## HISTORIC AND DESIGN REVIEW COMMISSION

August 07, 2019

**HDRC CASE NO:** 2019-397  
**COMMON NAME:** 202 WEAVER  
**LEGAL DESCRIPTION:** NCB 6517 BLK 6 LOT 44 (MISSION GROVE)  
**ZONING:** H  
**CITY COUNCIL DIST.:** 3  
**DISTRICT:** Mission Historic District  
**APPLICANT:** Office of Historic Preservation  
**TYPE OF WORK:** Recommendation to the Building Standards Board  
**APPLICATION RECEIVED:** July 16, 2019  
**60-DAY REVIEW:** September 14, 2019  
**CASE MANAGER:** Edward Hall  
**REQUEST:**

The applicant is requesting a recommendation to the Building Standards Board for the primary historic structure located at 202 Weaver Street, located within the Mission Historic District.

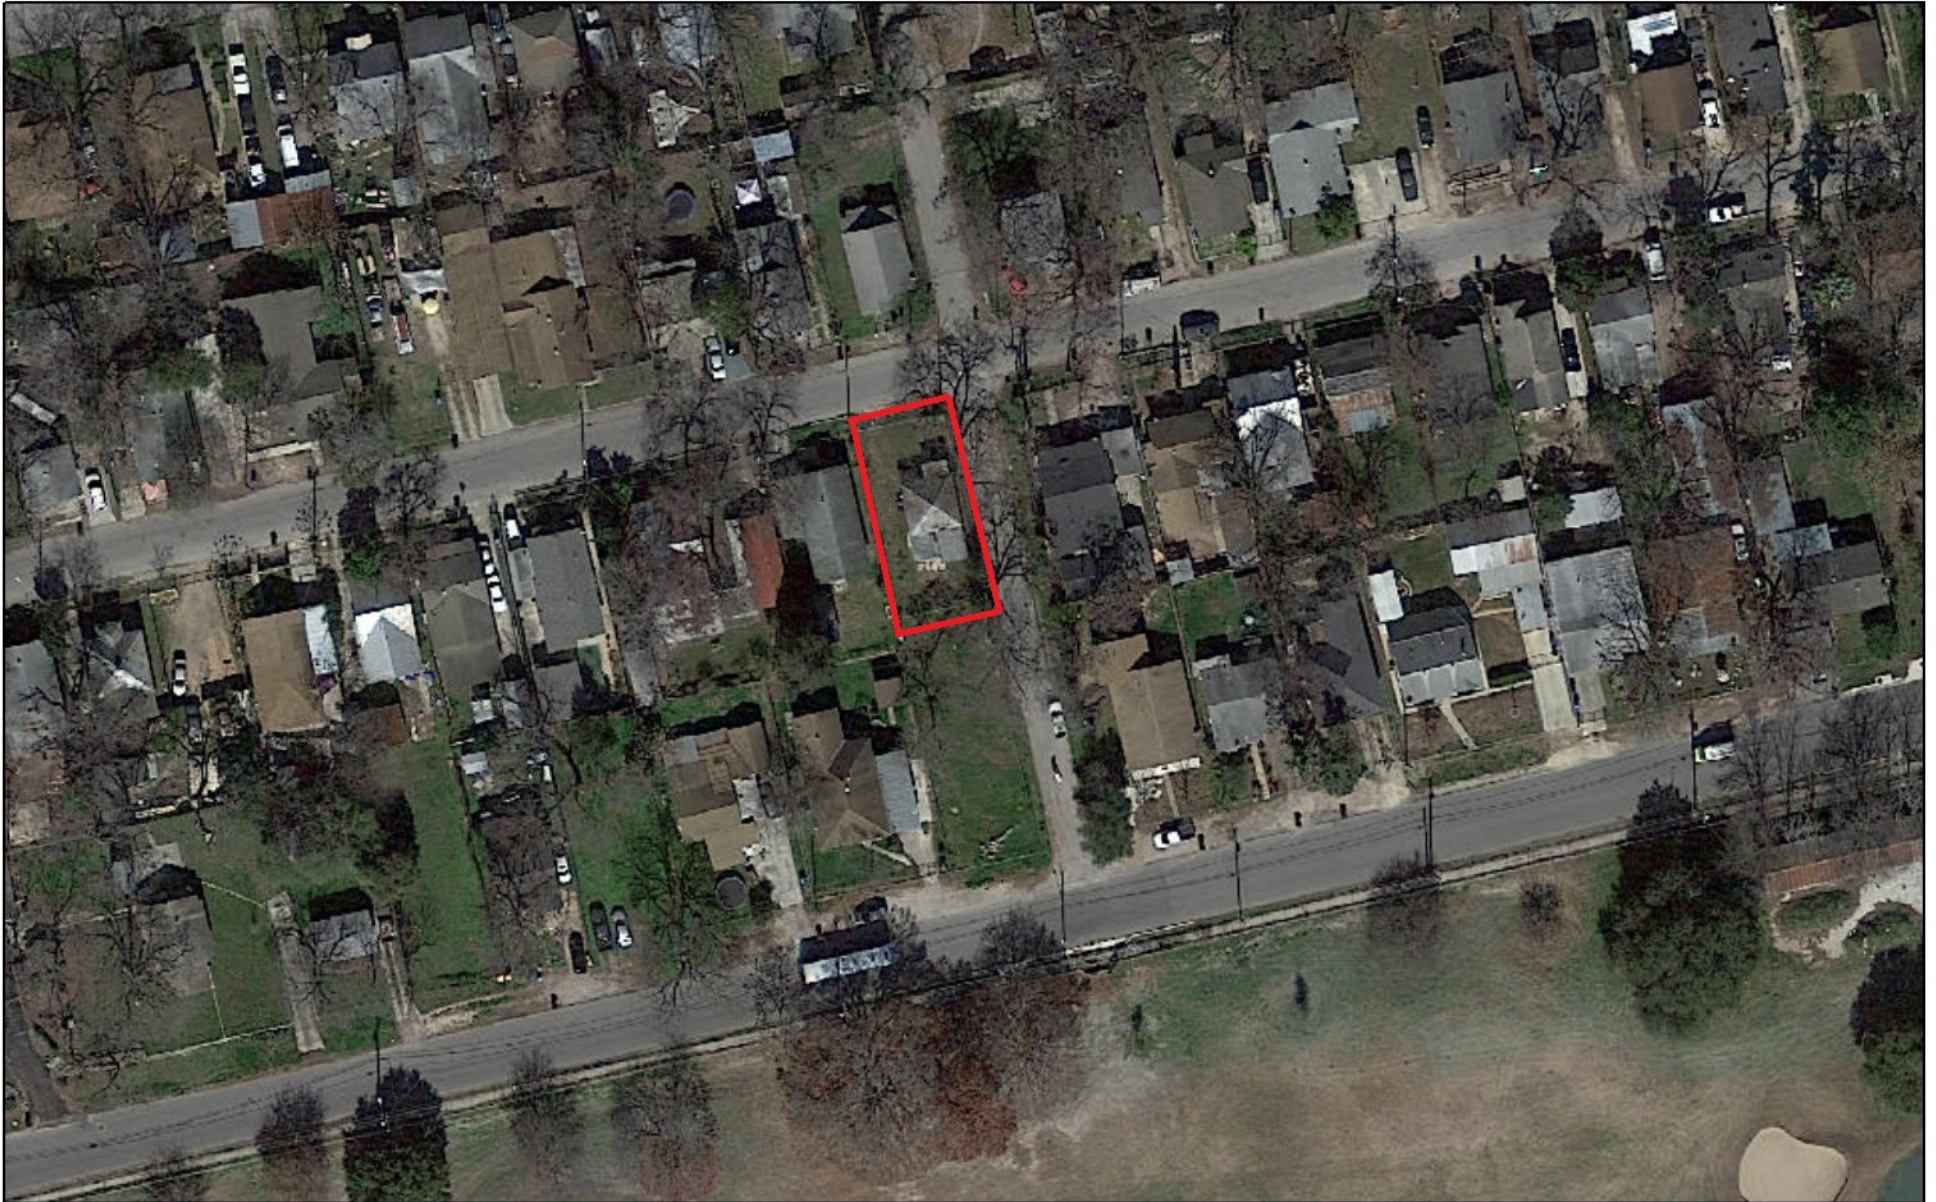
- a. The applicant is requesting a recommendation to the Building Standards Board for the primary historic structure located at 202 Weaver Street, located within the Mission Historic District. The structure was constructed circa 1935 and features traditional architectural features, wood windows, a hipped roof and #117 profile wood siding. This structure is contributing to the Mission Historic District.

- b. According to Development Services Department Code Enforcement staff, the primary historic structure features damage to the roof structure, siding, foundation, front and rear porches. The City's Code Enforcement Division inspected the property and determined it to be eligible for repair. The Historic Design Guidelines for Exterior Maintenance and Alterations note that historic exterior elements should be preserved where they remain or replaced or reconstructed in-kind of damaged. When new materials are needed, they should match the existing materials in color, configuration, durability, and texture. The repair and replacement of wood siding, wood trim, wooden porch elements, and roofing elements is eligible for administrative approval.

Staff recommends repair of the primary historic structure based on findings a and b. The Certificate of Appropriateness for repair of this structure is eligible for administrative approval. No exterior work should commence prior to the issuance of a COA.
